**LOCAL HISTORIC DISTRICT:** Wilmore

**PROPERTY ADDRESS:** 429 West Park Avenue

**SUMMARY OF REQUEST:** Painted Brick/Front Door Replacement

# HDCRMI 2019-00444

## FRONT PORCH LEFT COLUMN

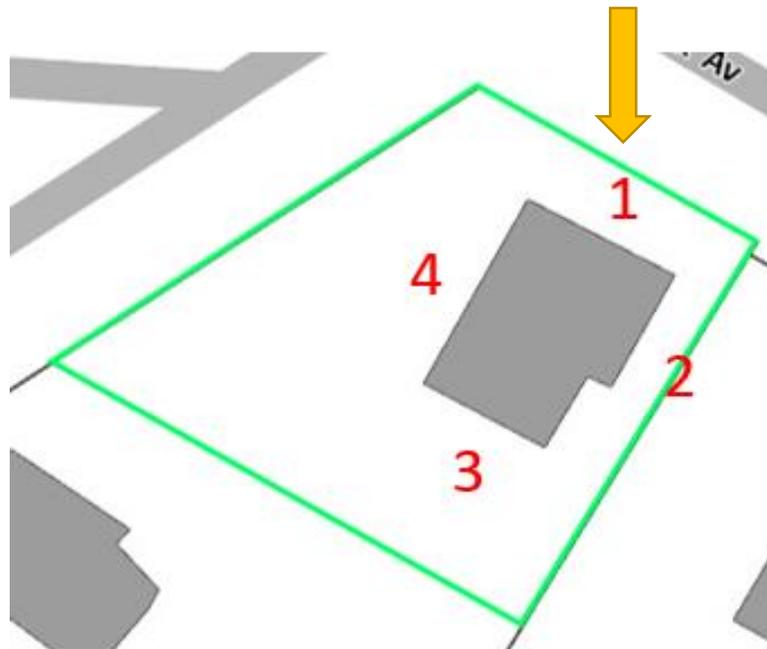
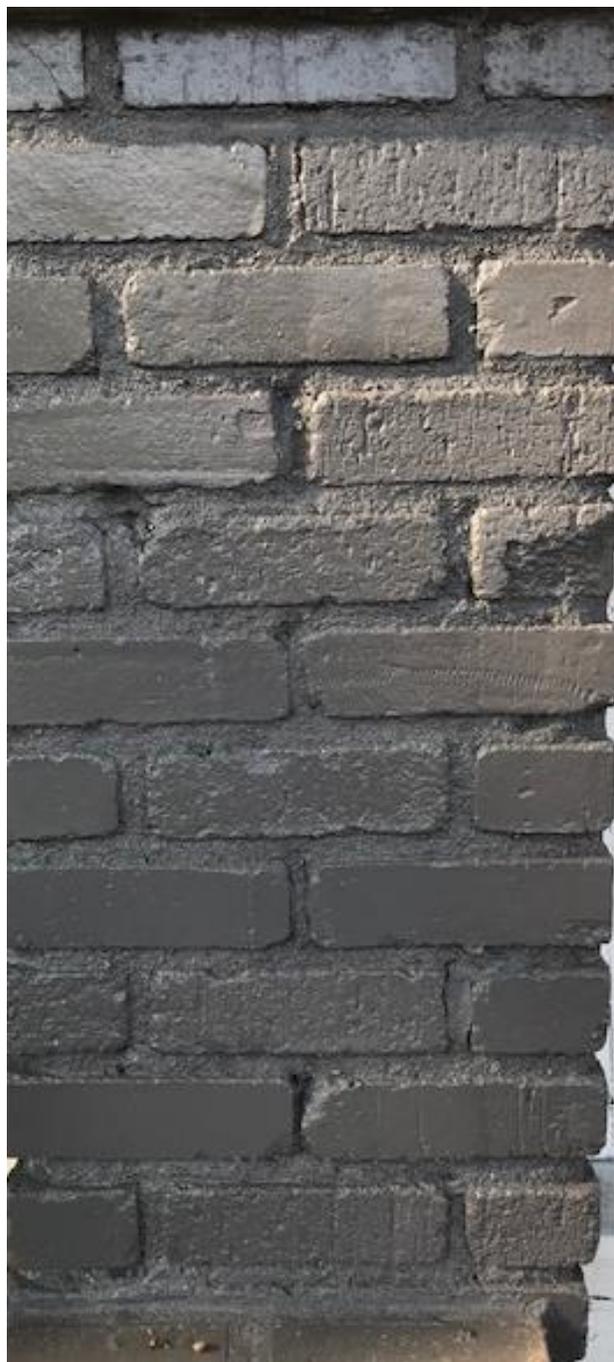
- Mismatched brick (smooth and scored face)
- Inconsistent mortar head (vertical) joint widths
- Uneven & un-tooled joints
- Broken brick & mortar drips

## FRONT PORCH RIGHT COLUMN

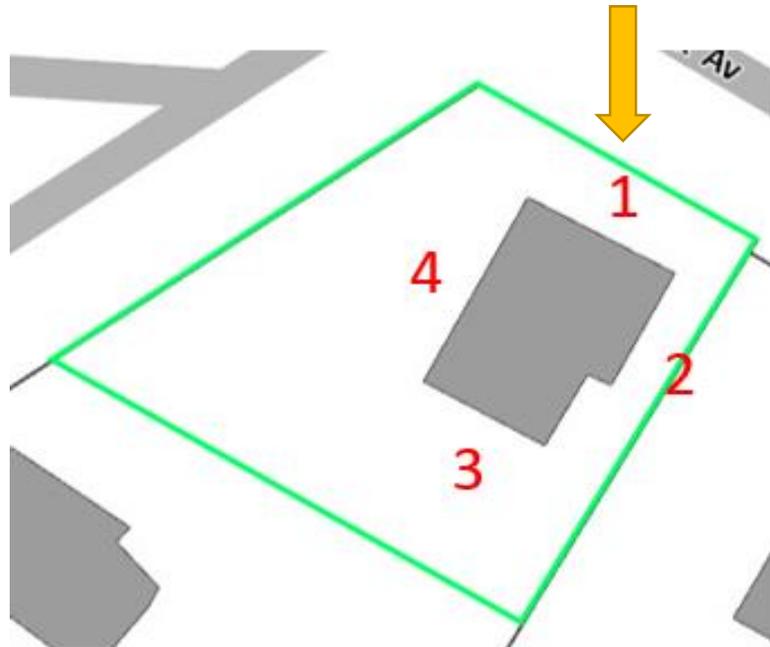
- Caved in brick
- Crooked and irregular joints
- Broken brick
- Substandard mortar and joint lines
- Inferior masonry workmanship

## FRONT PORCH RIGHT COLUMN

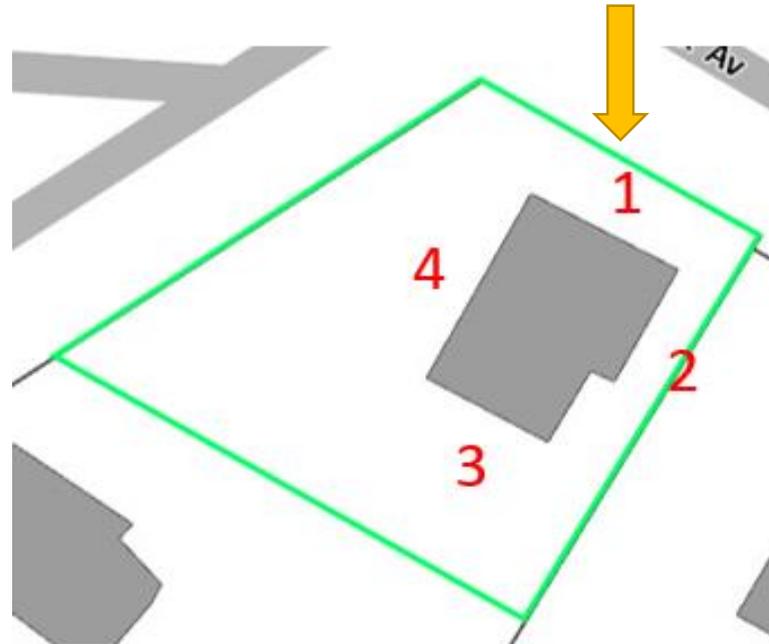
- Inconsistent mortar joints
- Crooked and irregular joints
- Substandard mortar and joint lines

## NORTHWEST SIDE FRONT PORCH

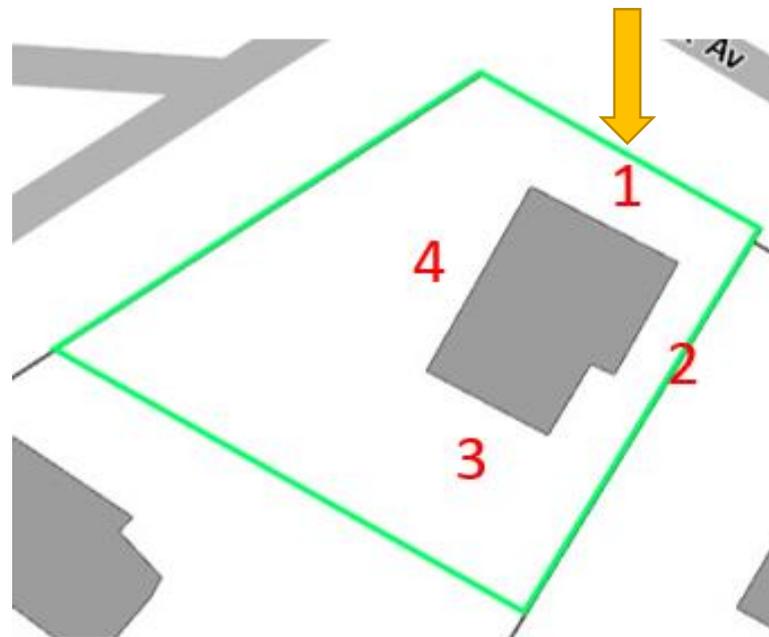
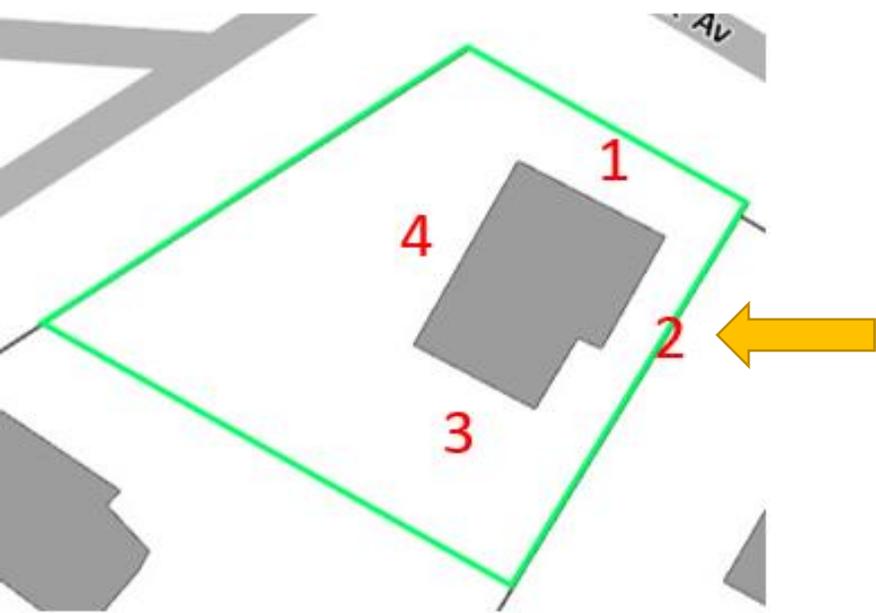
- Overfilled mortar joints
- Mismatched brick
- Uneven rows of brick at the joint.
- Inferior masonry workmanship

## EAST SIDE COLUMN

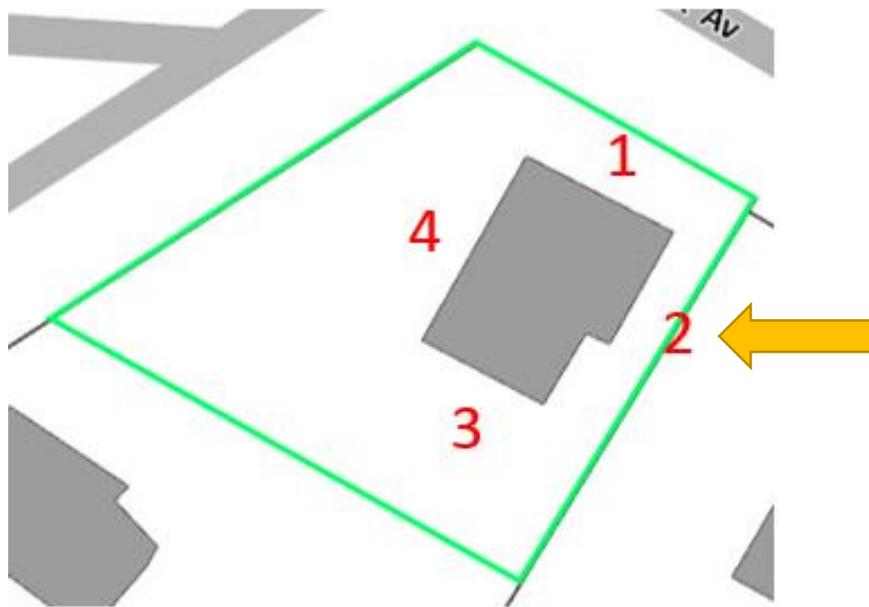
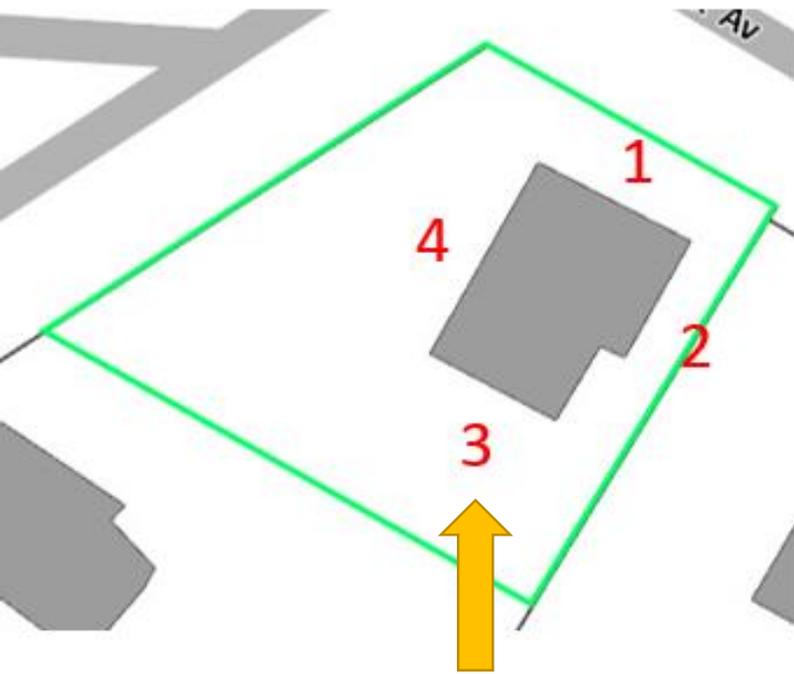
- Under-filled & mismatched mortar (horizontal & vertical) lines
- Inferior masonry workmanship.
- Uneven rows and substandard mortar and joint lines

# CHIMNEY PAINTED PRIOR TO RENOVATION

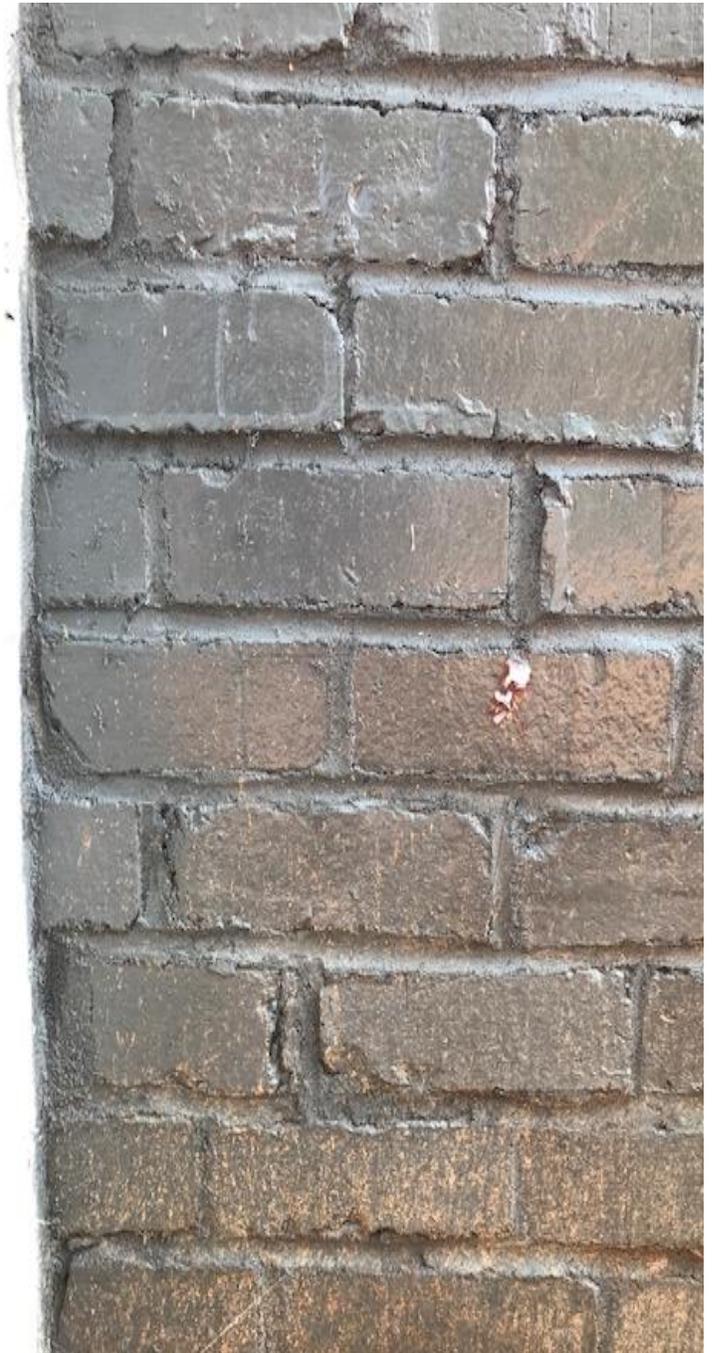
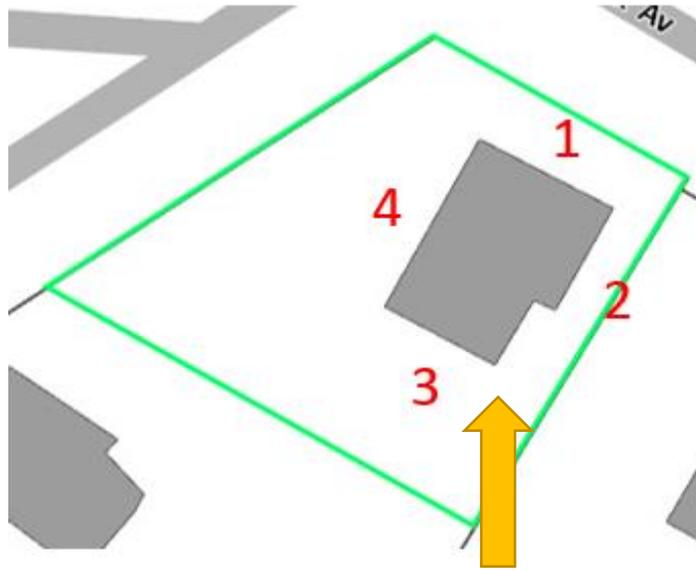
- Mismatched mortar (horizontal & vertical) lines
- Joint lines don't line up in brick pattern.
- Uneven rows and substandard mortar and joint lines

## WEST SIDE

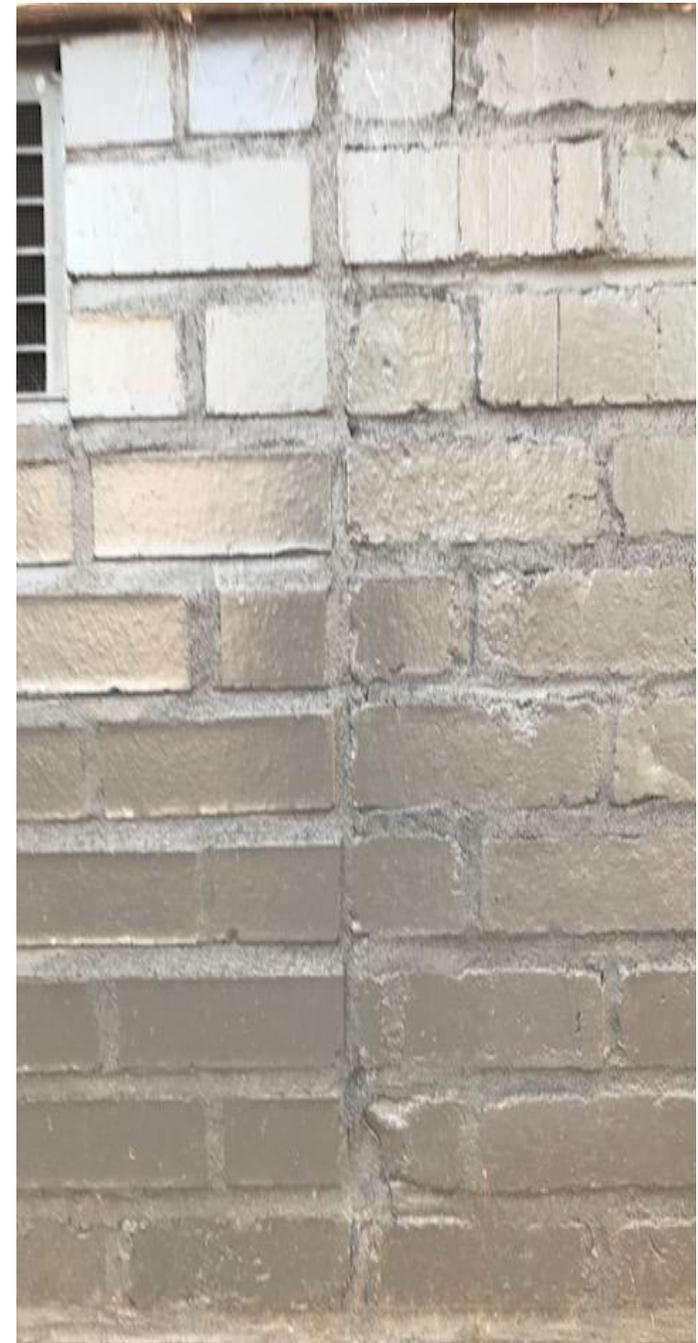
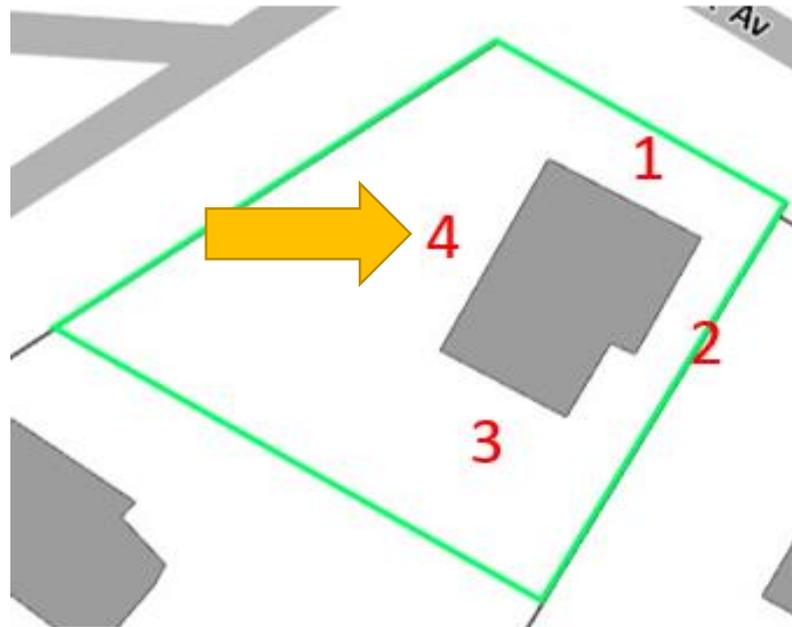
- Excessive and sloppy mortar work
- Uneven joint lines
- Bricks don't line up

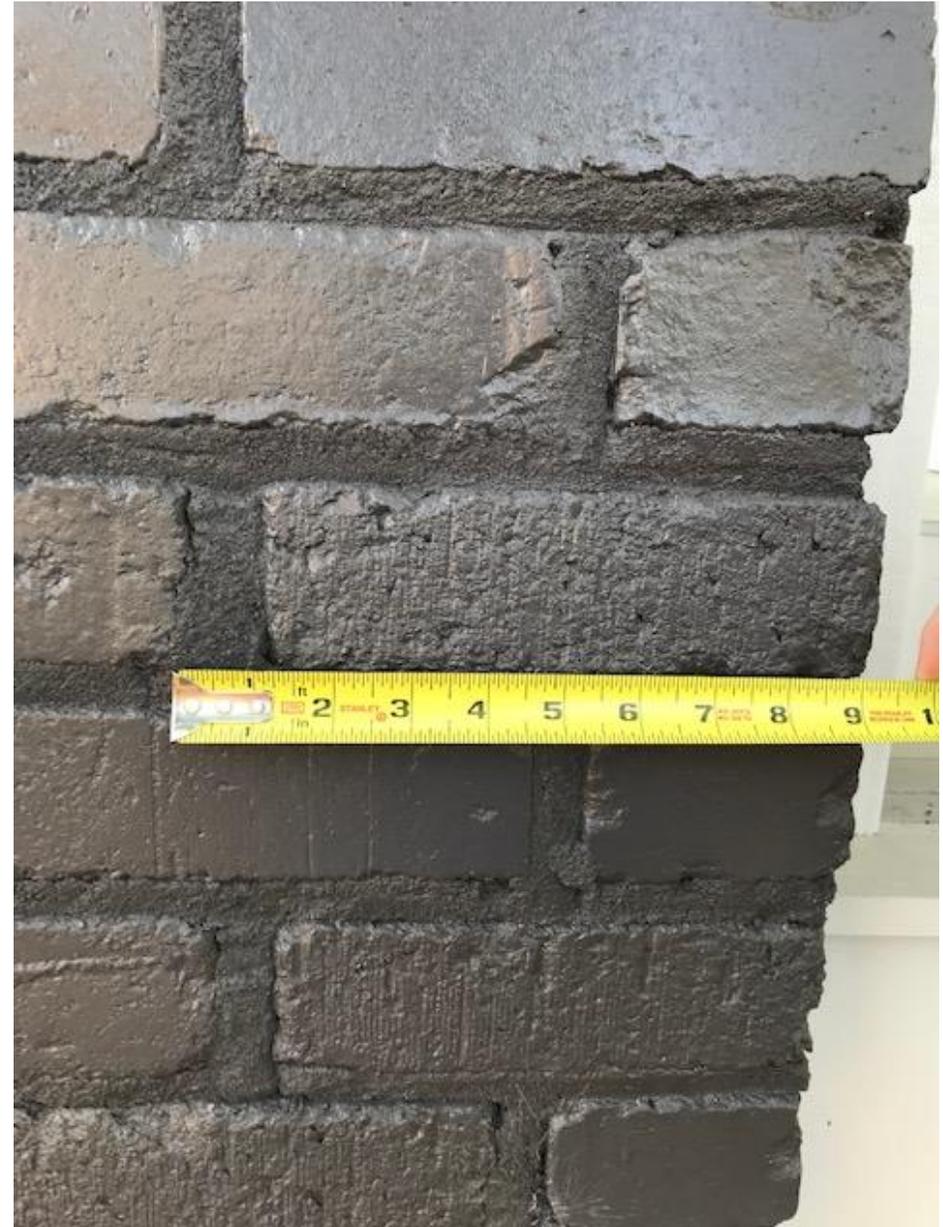
- Mortar head joints in excess of 1 inch common throughout all sides of house.
- Industry standard is 3/8"

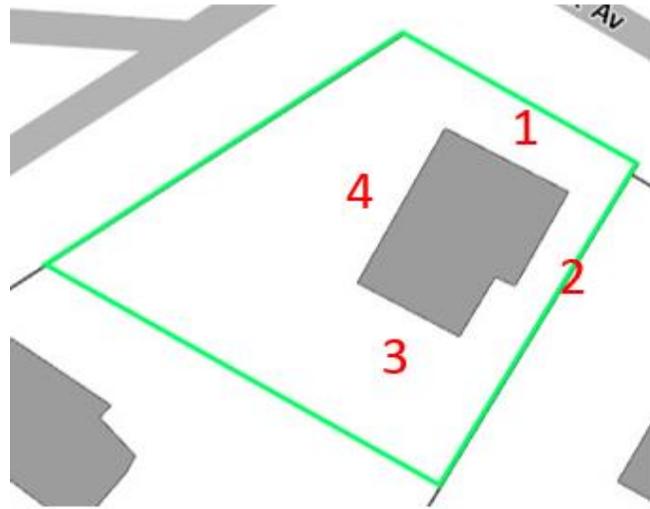
- Original front door | 15-light
- Serious disrepair with broken panes and wood rot.

- Replaced with a custom, solid wood, 8-light door.
